DURANGO SITE
DURANGO, COLORADO
BODO CANYON DISPOSAL SITE

PROFILE AND SECTIONS
DEWATERING TRENCH SYSTEM

NVP Data Logger Hydrograph

CALCULATION COVER SHEET

Durango Toe Drain Longterm Seismic w/ Phreatic EQh = 0.16 ru=0.2 Block Failure
 Ten Most Critical. C:DURTDHW2.PLT By: RAM 09-20-94 2:03pm

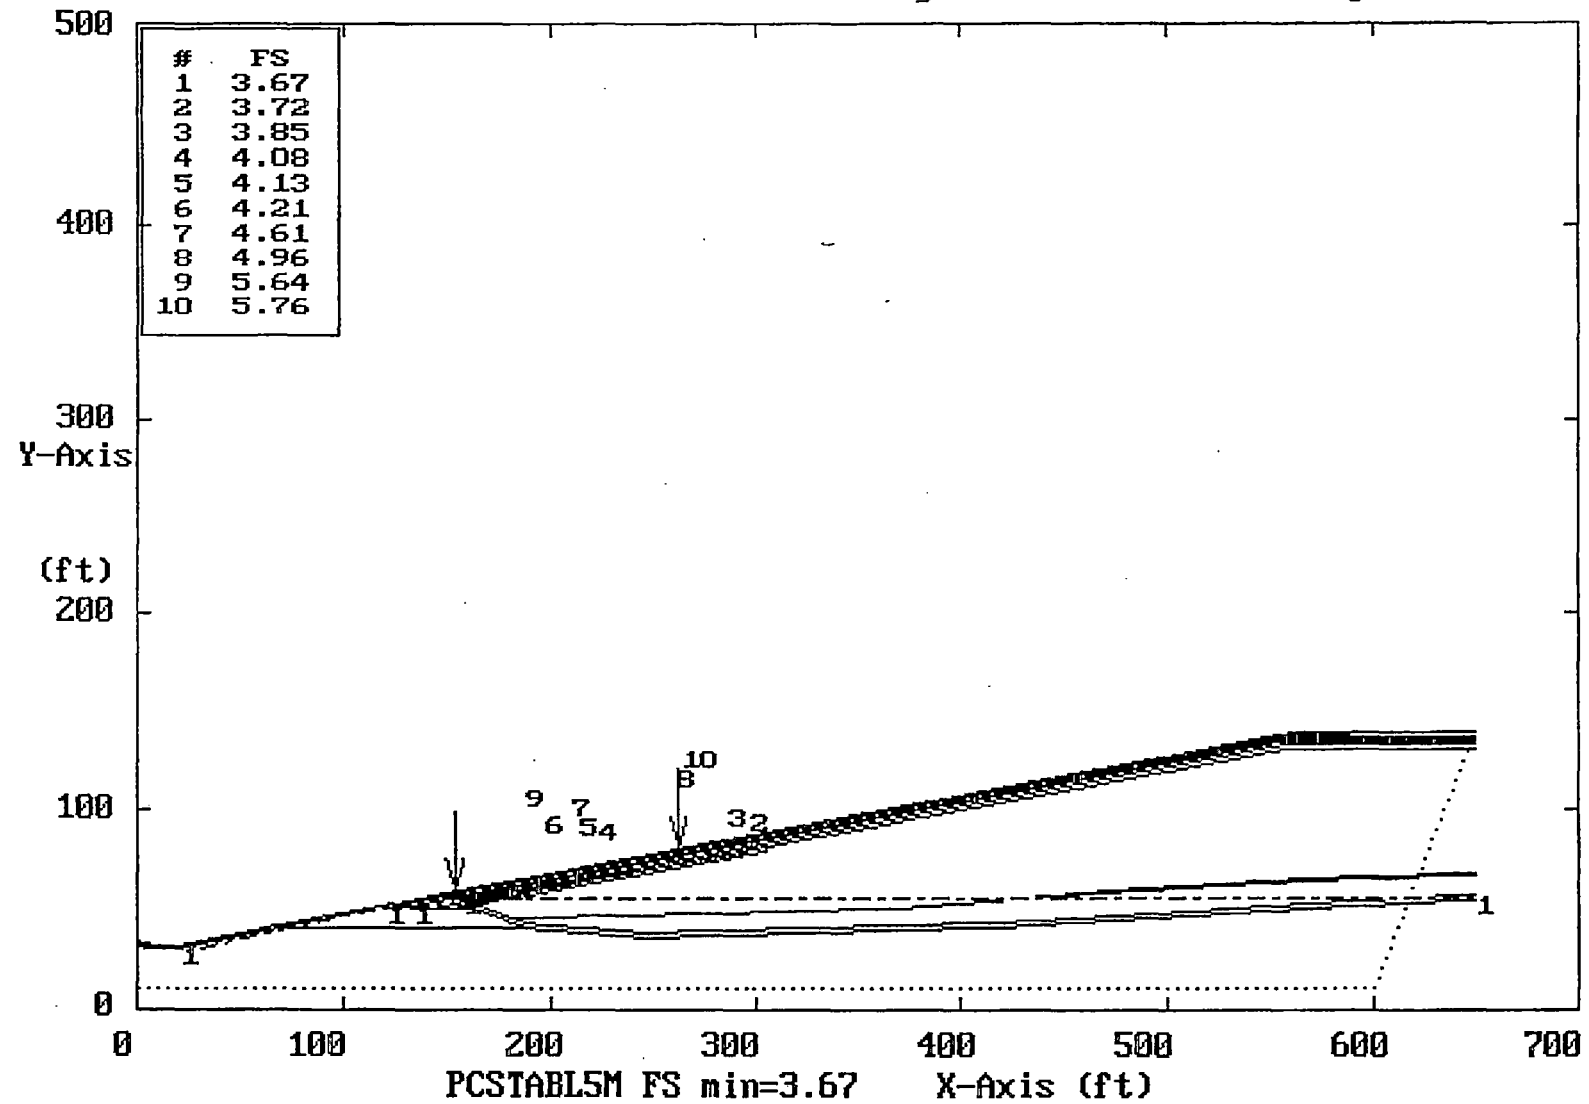
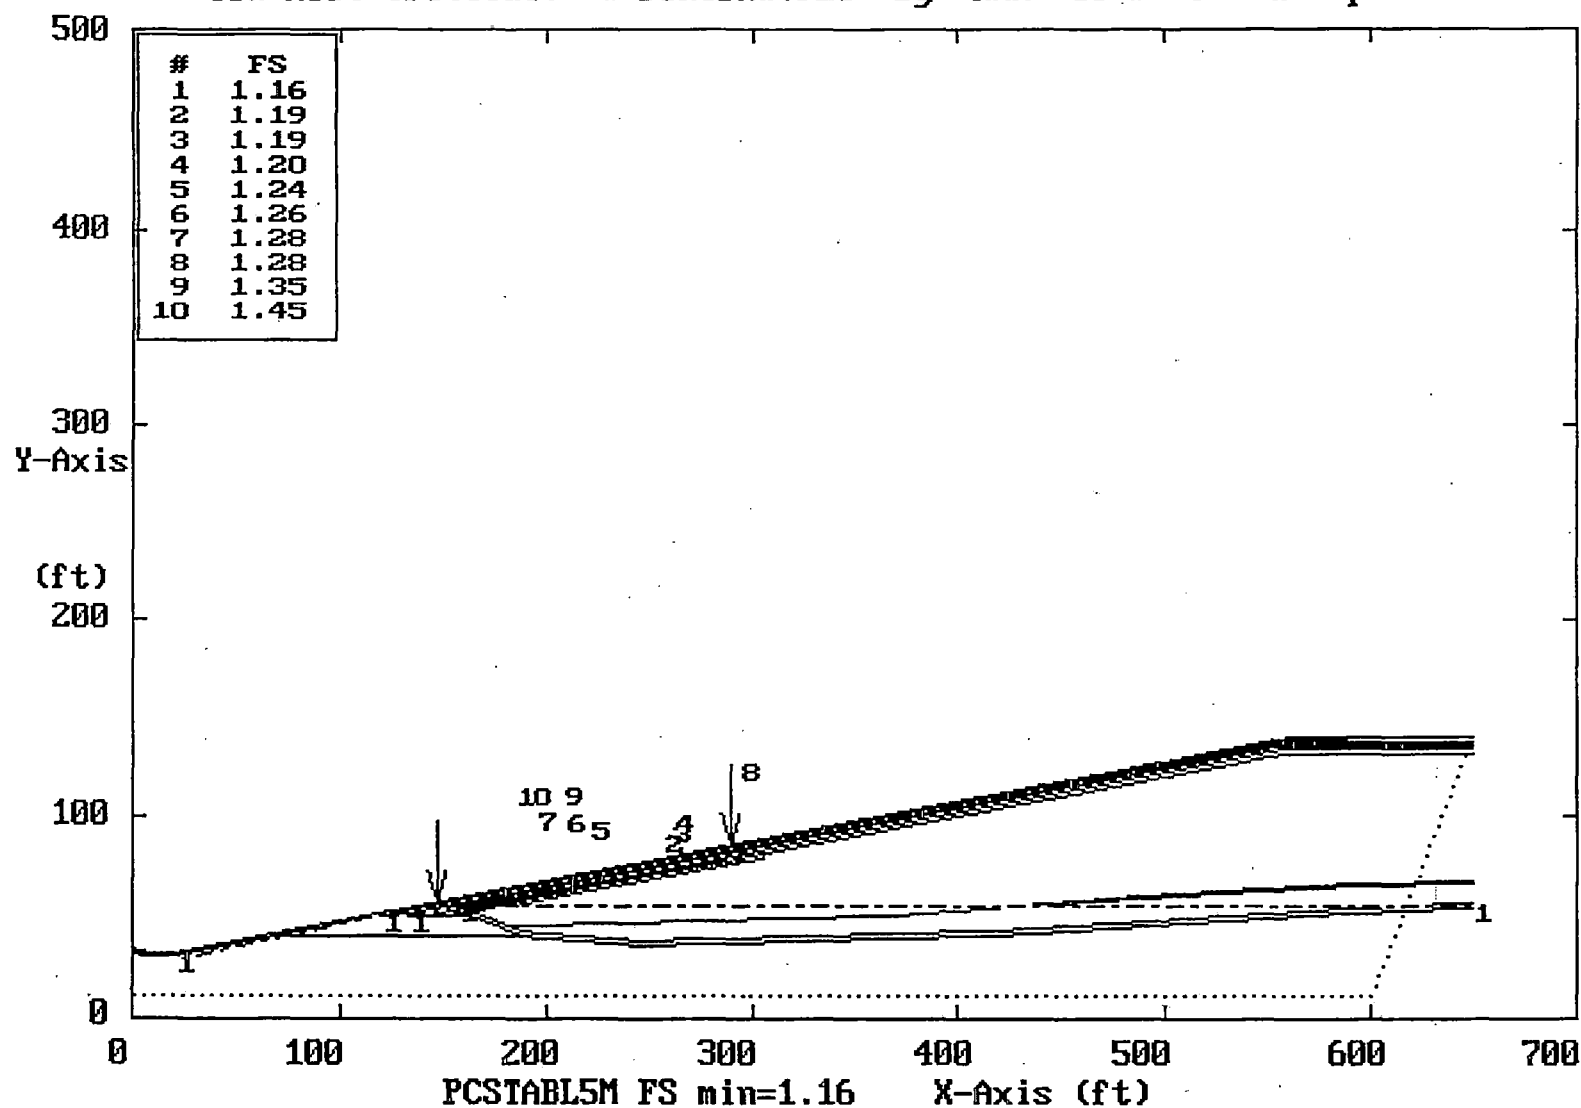
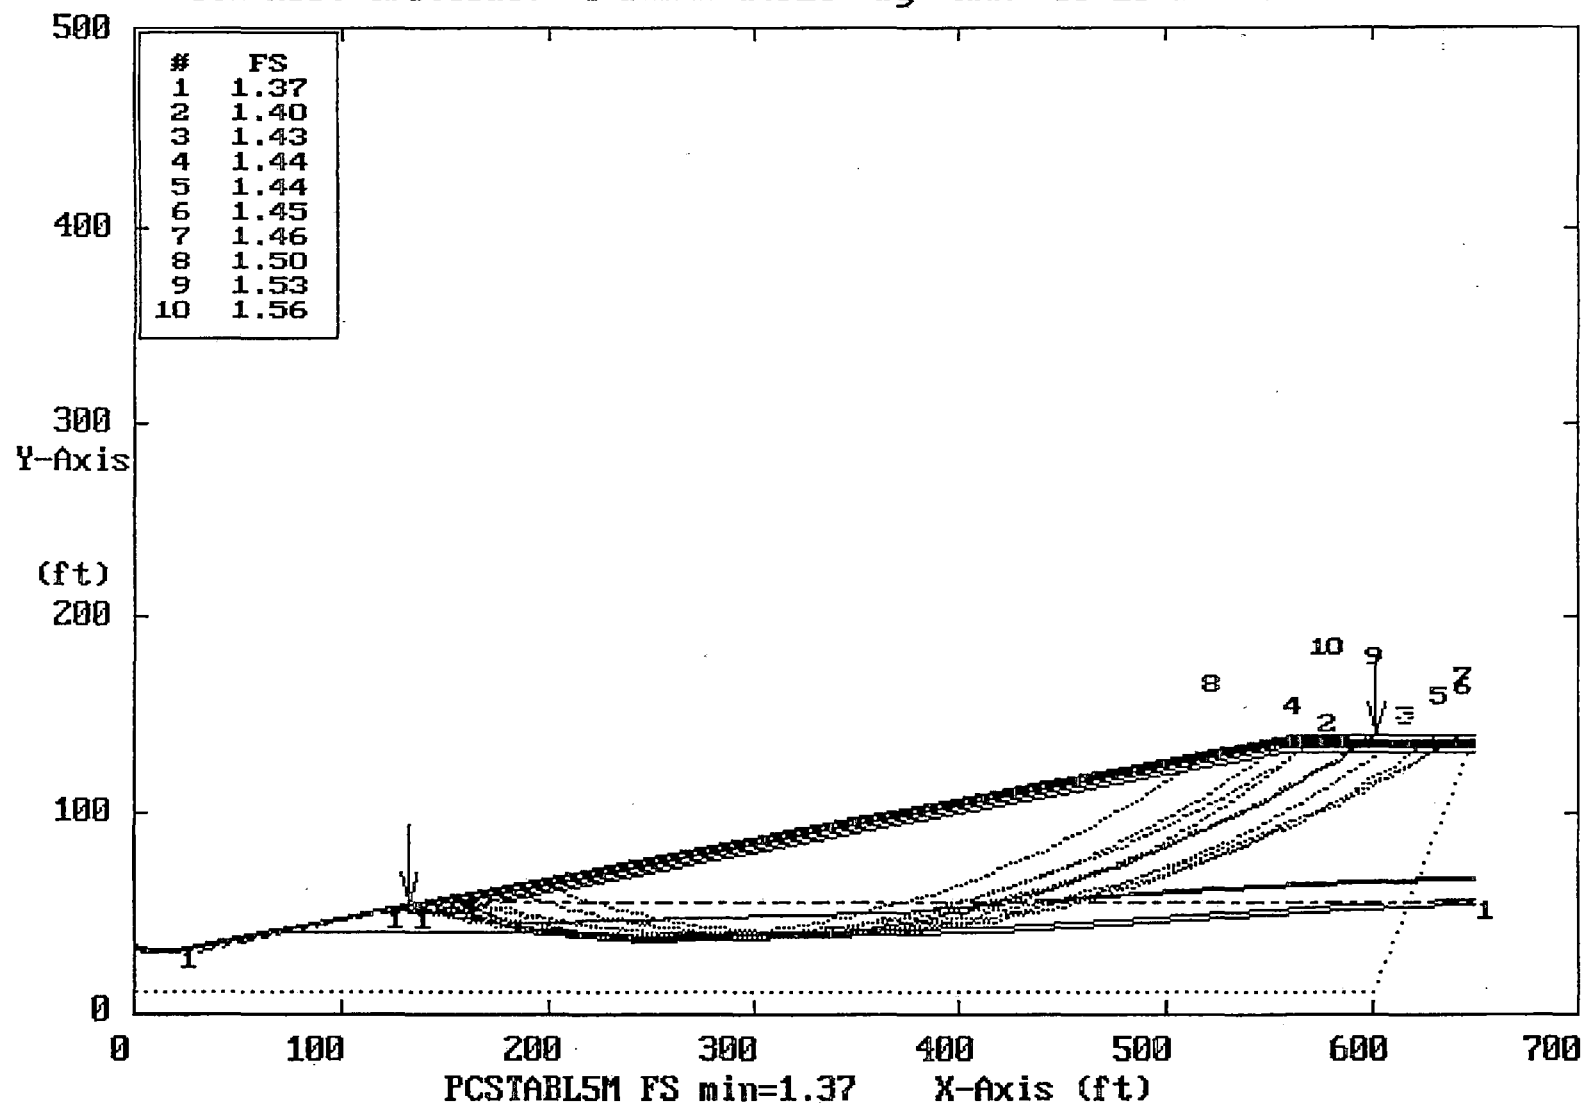
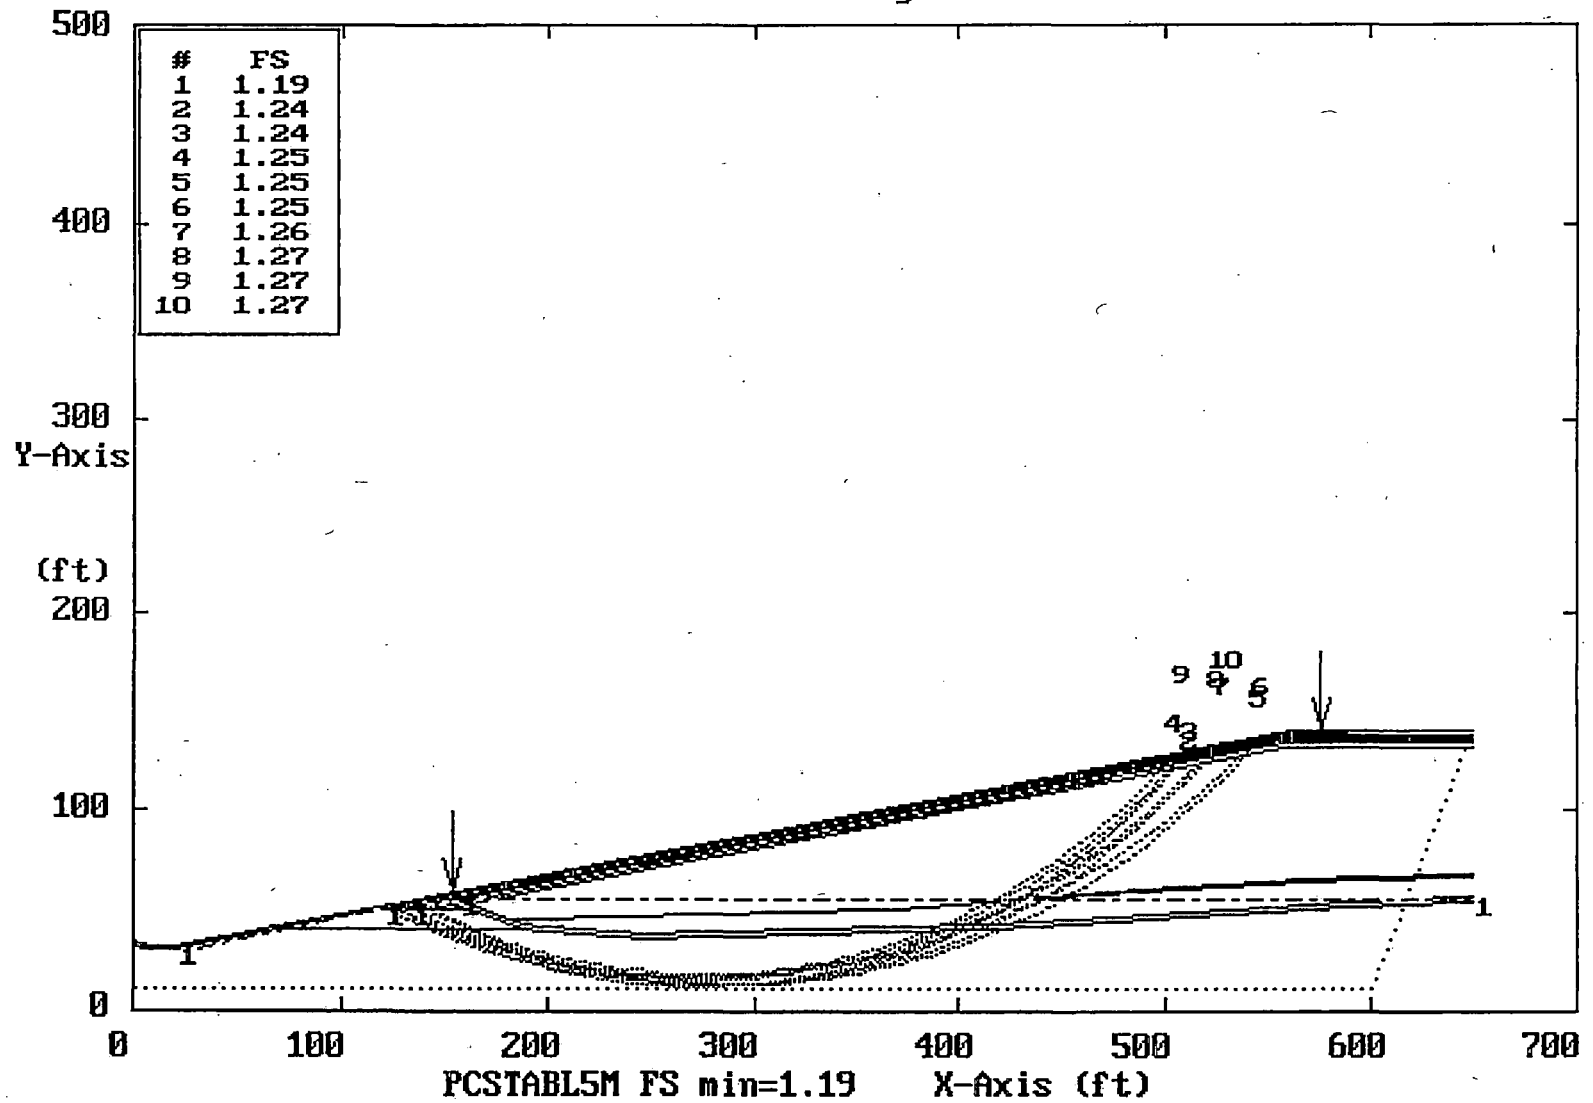
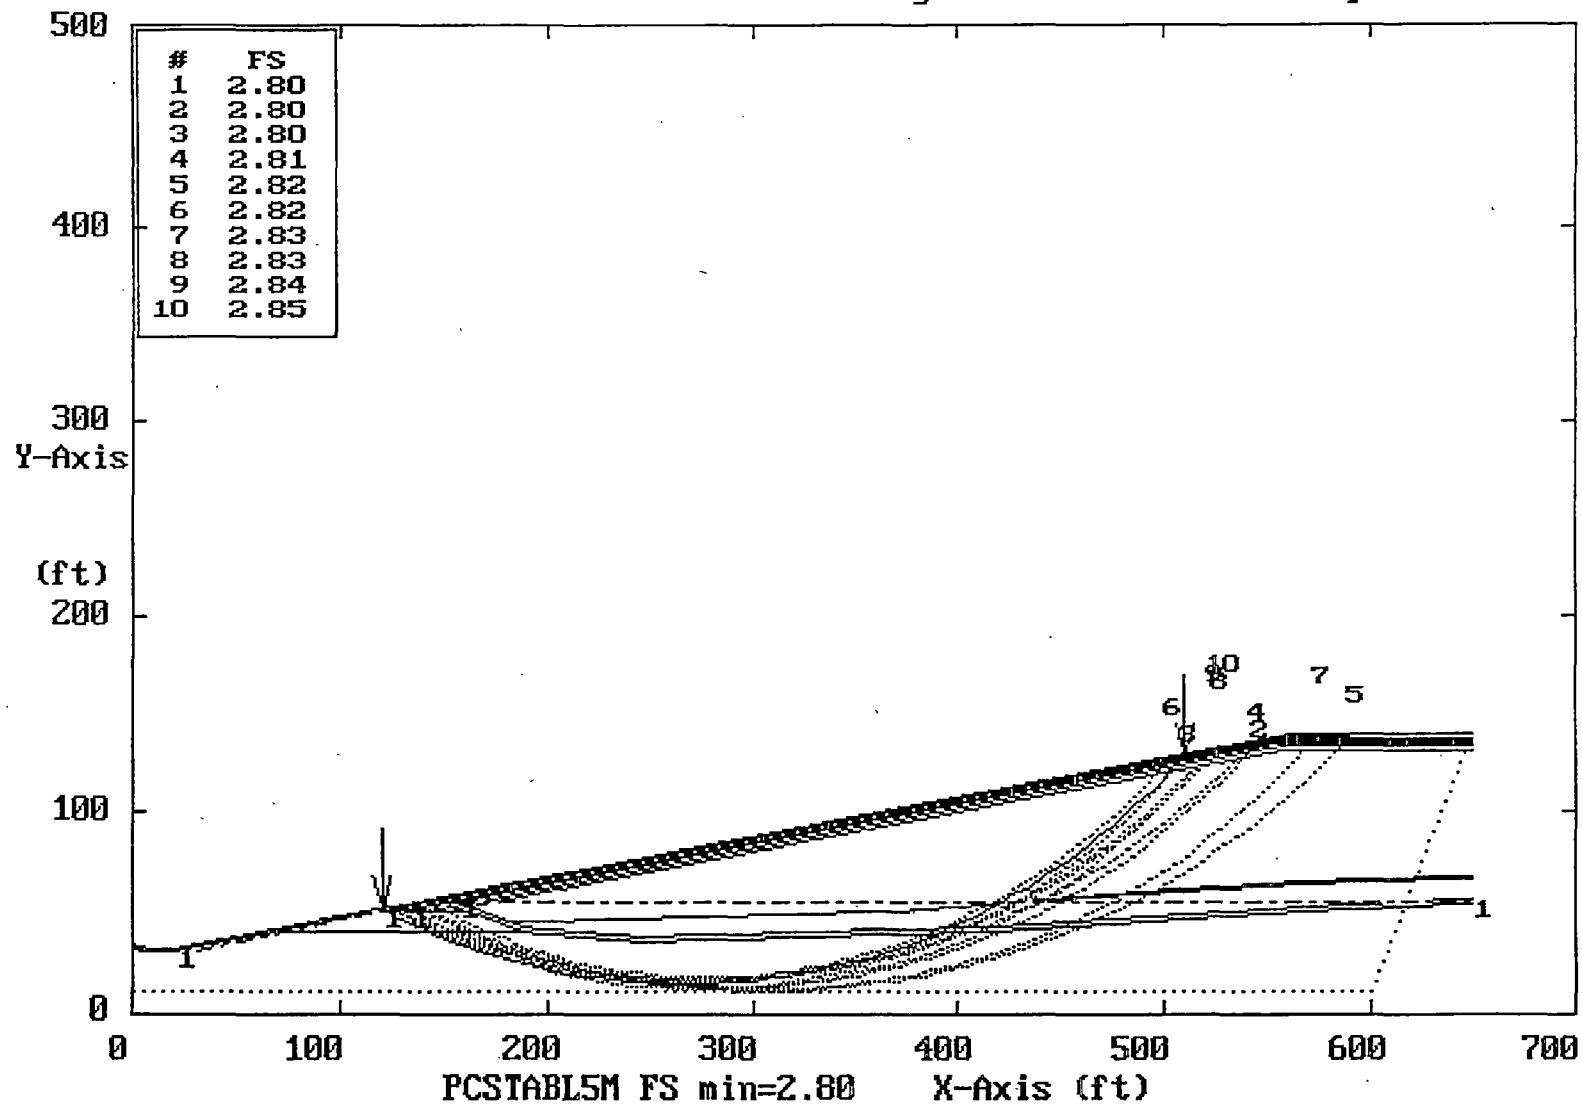
Letter is in response to a request to review a slope stability analysis performed by Jacobs Engineering Group (JEG) for the UMTRA Durango Disposal Cell at Bodo Canyon in 1994. The analysis was performed to determine the effect on disposal cell slope stability if a toe drain on the eastern slope is permanently closed. Closing the drain will cause an increase in the phreatic surface within the tailings assuming infiltration is the source of inflow.

The slope stability analysis performed by JEG was done to verify the initial stability analysis made during the initial design of the disposal cell by Morrison Knudsen Environmental Services (MKES)¹. In the MKES computation, the slope was determined to be stable with a functioning toe drain. JEG ran the analysis assuming the toe drain was closed creating an elevated internal water surface within the embankment. JEG used an updated version of the same slope stability computer code MKES had used (PCSTABL). JEG used more conservative soil strength parameters and included formation of internal pore pressures that would likely develop during shaking in a seismic event. An increase in pore pressure reduces the soil's shear strength. A horizontal acceleration of 0.16g was used in the calculation which is an applied horizontal force of 16% gravity. Additionally, JEG considered a variety of failure modes (both circular and block failure shapes) that had not been previously analyzed.
